# Access Compliance Report

## Public Rights-of-Way

### (Curb Ramps)

Intersection ID: 12377	Main Street: S_TRYON_ST	Cross Street: E_4TH_ST	Location: S
ADA ID: B53EDAF09704	Ramp Type: PerpDiag	Initial Pass/Fail: Pass	Overall Compliance: No
		Severity Score: 7.5

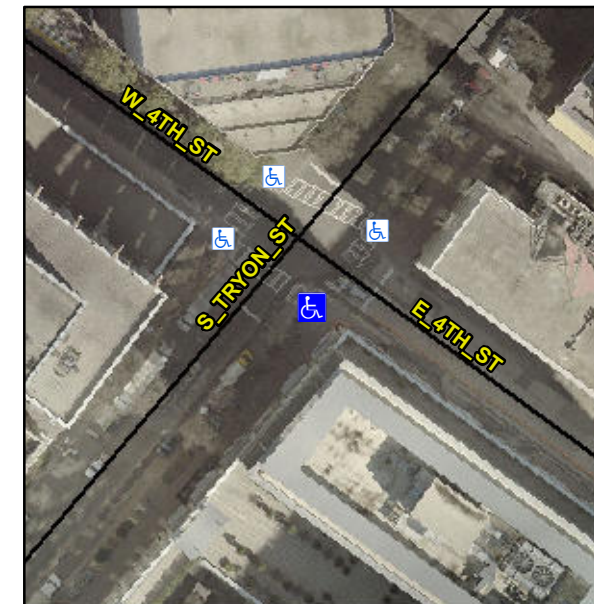
**Grind Gutter Lip.**

**R302.7.2**
